POUDRE SCHOOL DISTRICT R-1
NEW FORT COLLINS HIGH SCHOOL
FORT COLLINS COLORADO

FIRST FLOOR PLAN
ADMINISTRATION
DINING & COMMONS

FIRST FLOOR PLAN
AREA H

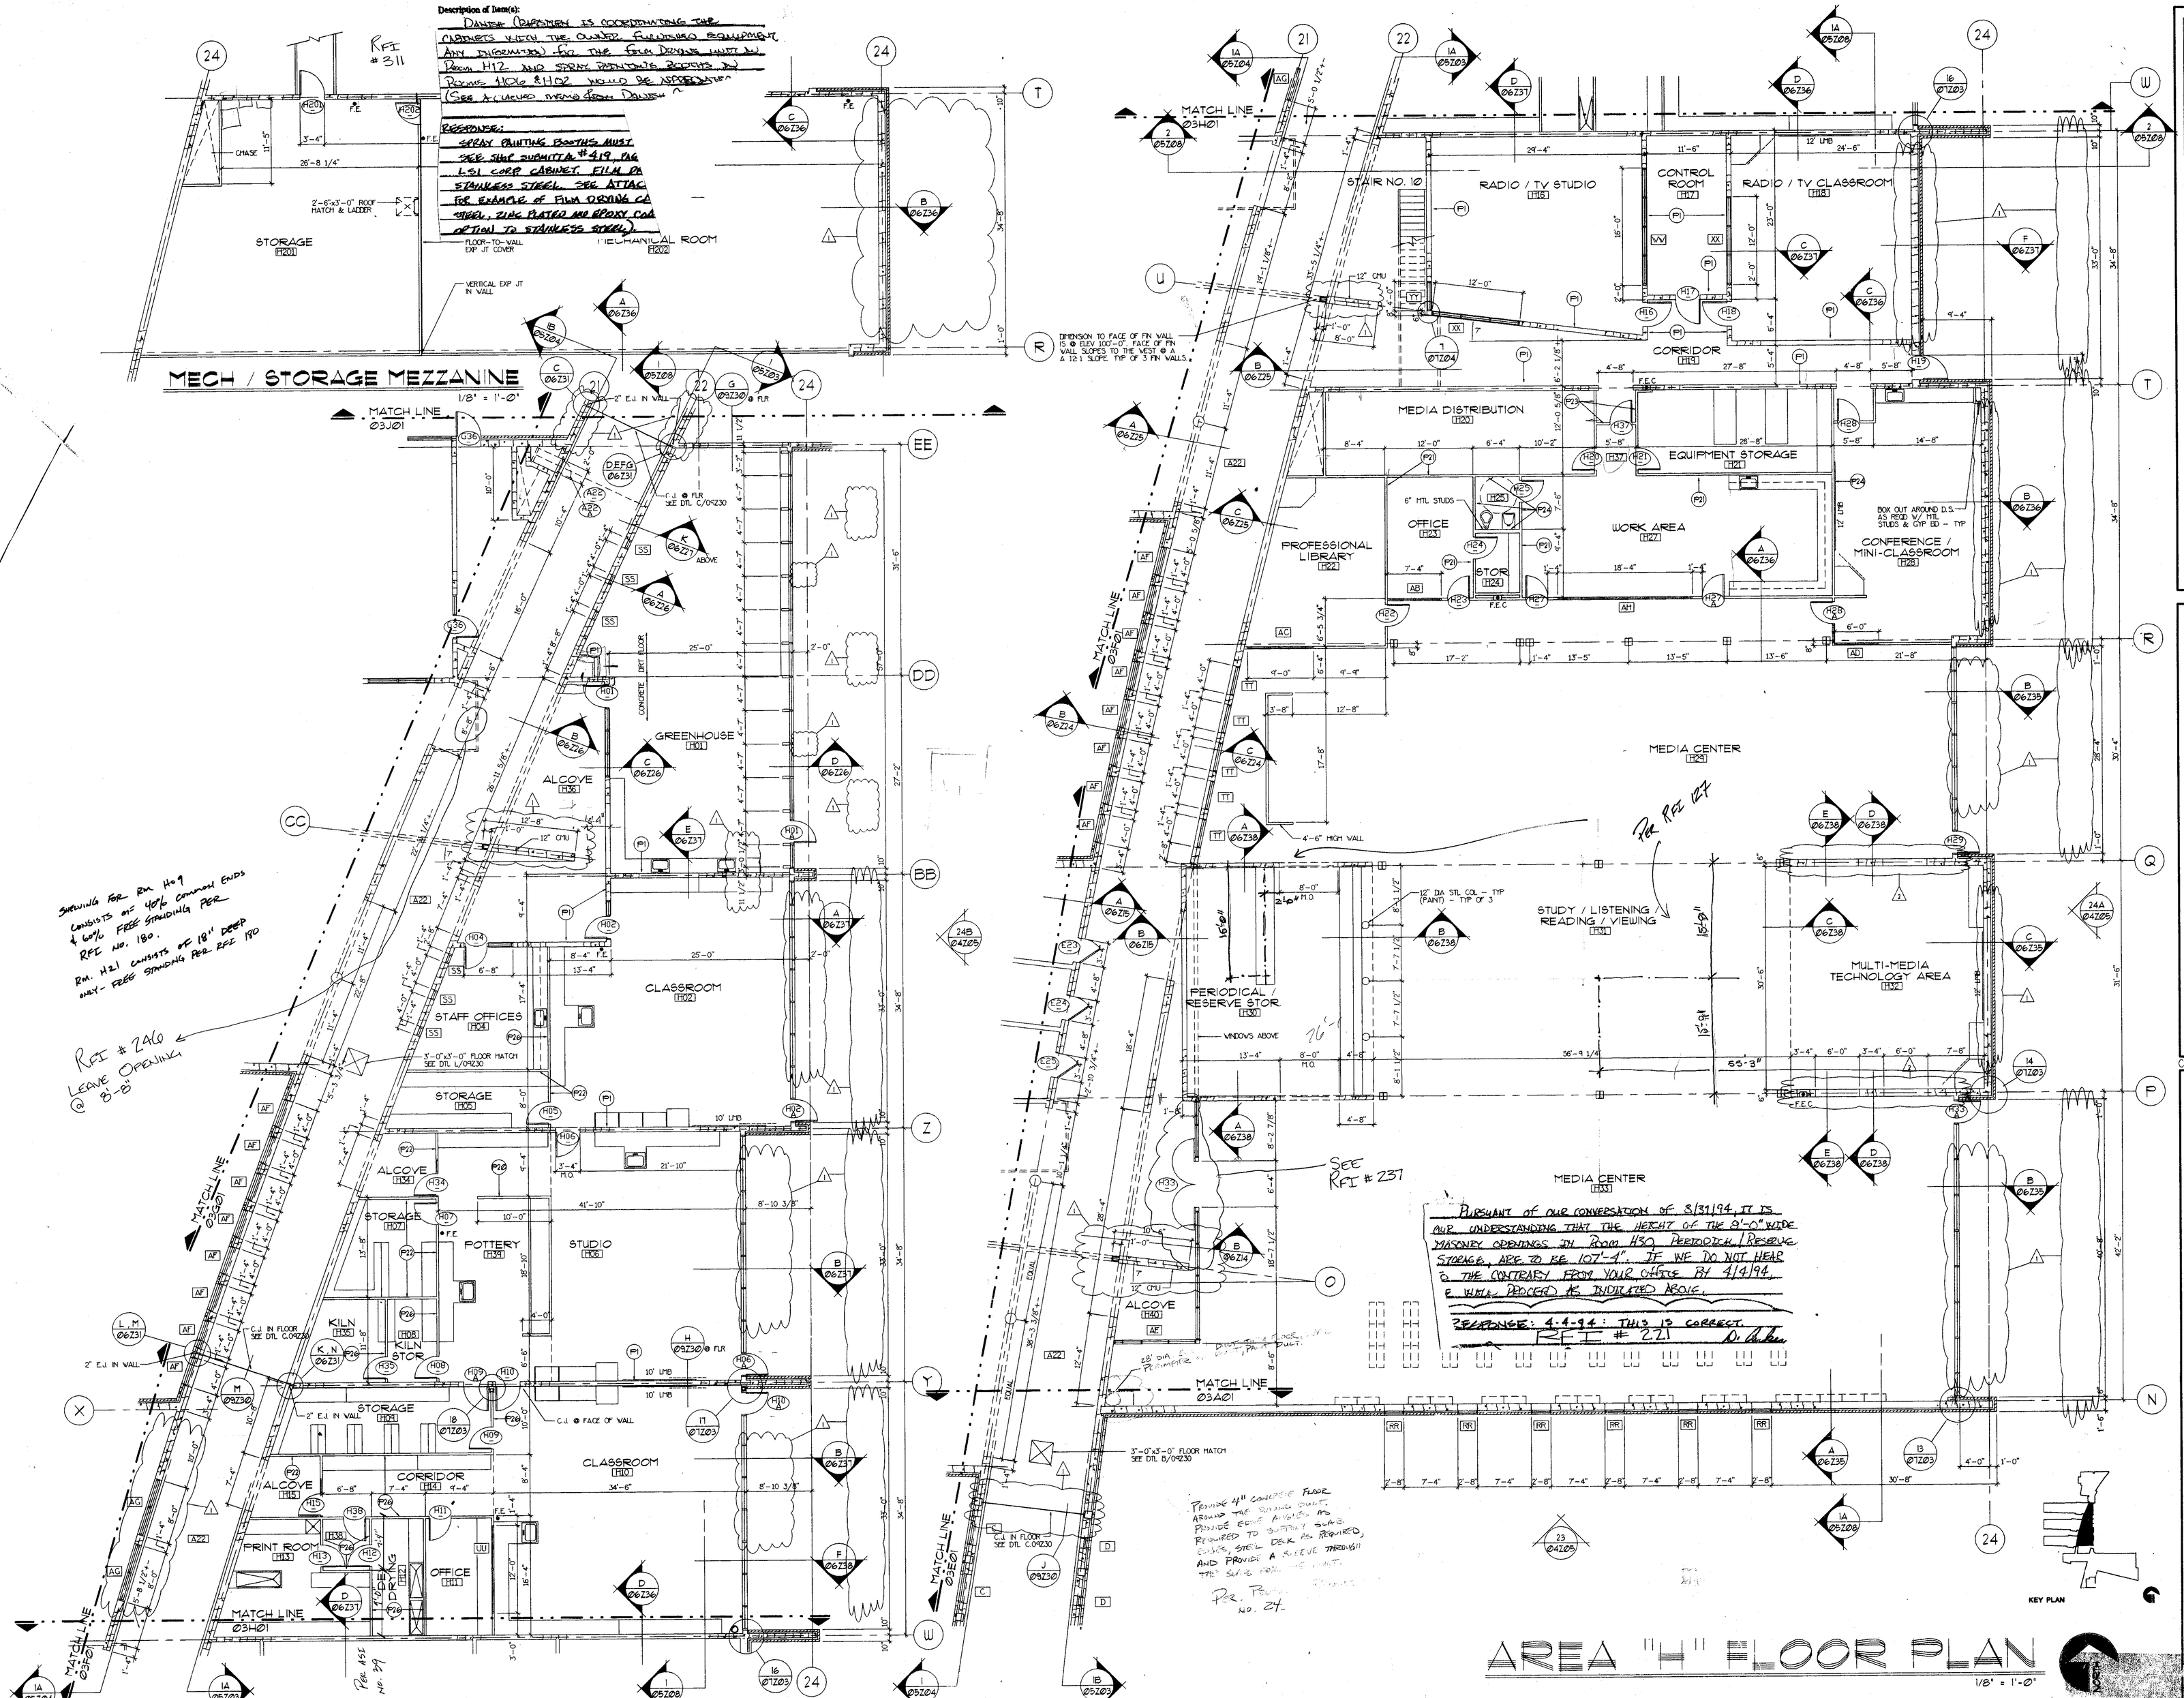
SHELVING FOR RM. H09 CONSISTS OF 40% COMMON ENDS & 60% FREE STANDING PER RFI NO. 190.
RM. H21 CONSISTS OF 18" DEEP ONLY - FREE STANDING PER RFI 190

RFI #246
LEAVE OPENING @ 8'-8"

PURSUANT OF OUR CONVERSATION OF 3/31/94, IT IS OUR UNDERSTANDING THAT THE HEIGHT OF THE 8'-0" WIDE MASONRY OPENINGS IN ROOM H30 PERIODICAL / RESERVE STORAGE, ARE TO BE 107'-4". IF WE DO NOT HEAR TO THE CONTRARY FROM YOUR OFFICE BY 4/4/94, WE WILL PROCEED AS INDICATED ABOVE.

PROVIDE 4" CONCRETE FLOOR AROUND THE BOILER UNITS. PROVIDE EDGE FORMS AS REQUIRED TO SUPPORT SLAB. CUTOUT STEEL DECK AS REQUIRED, AND PROVIDE A SLEEVE THROUGH THE SLAB FROM THE UNITS.
PER PROJECT MANUAL No. 24

RESPONSE: 4-4-94: THIS IS CORRECT.
RFI # 271

24A Ø4Z05 EAST ELEVATION AREA H
1/8" = 1'-0"

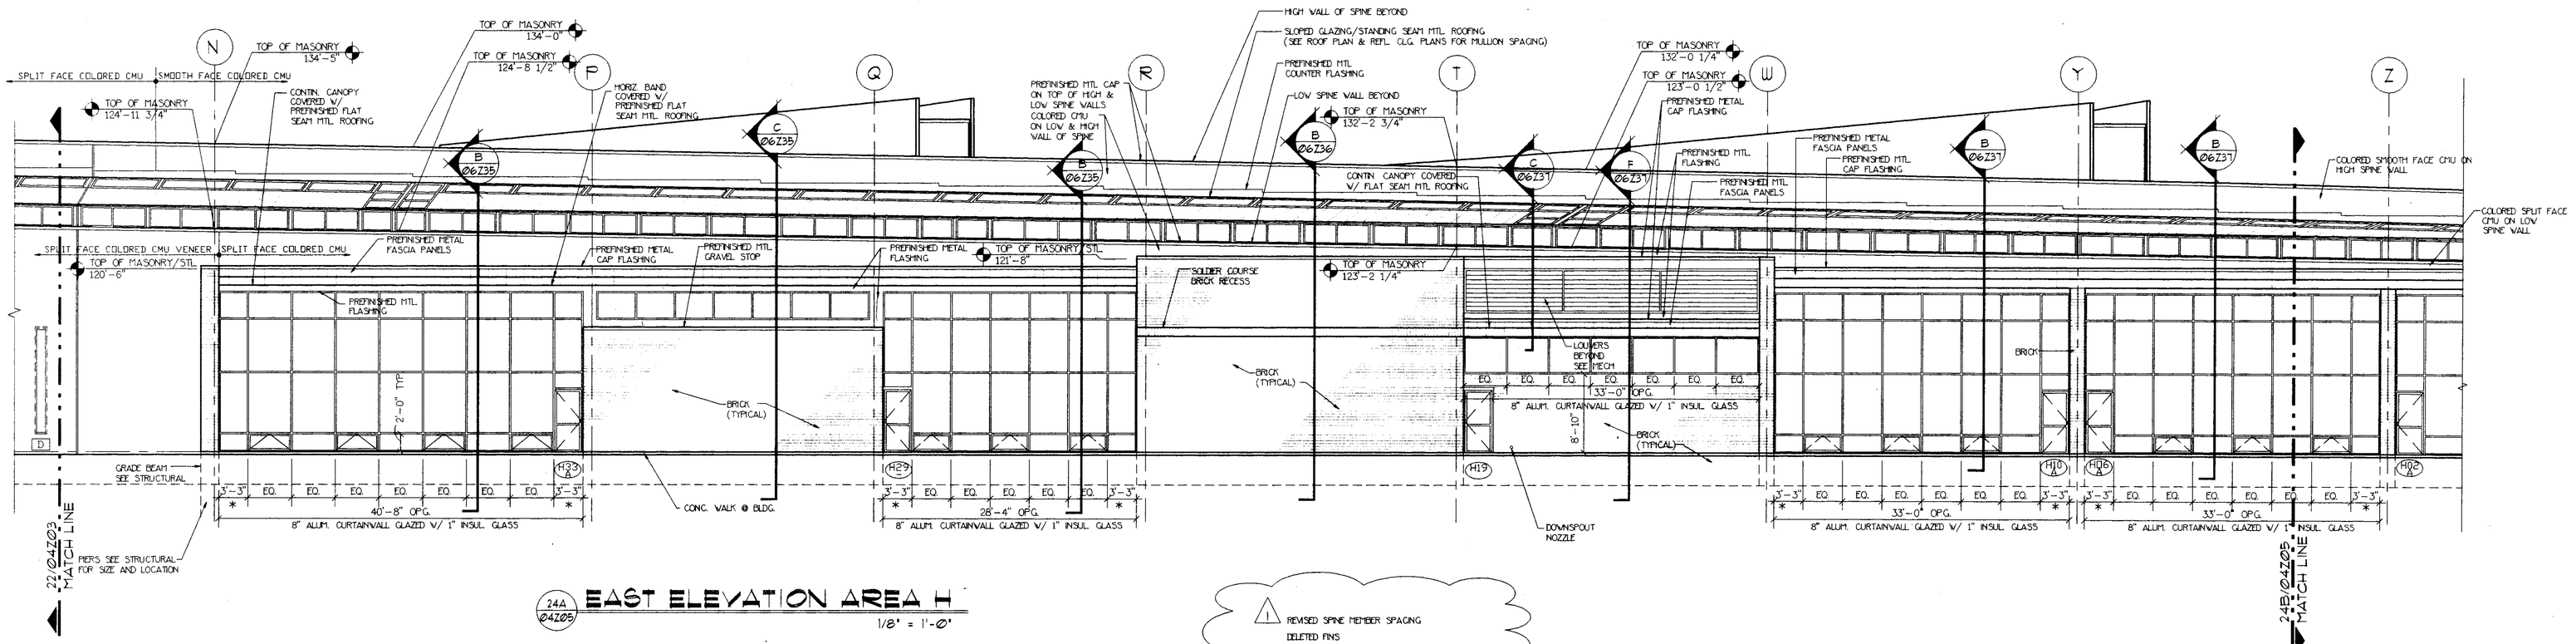
1 REVISED SPINE MEMBER SPACING
DELETED FINS
DELETED CANOPY & STUCCO-COVERED CMU COLS. @ EAST ELEV. OF H WING
DELETED GLASS BLOCK IN H WING
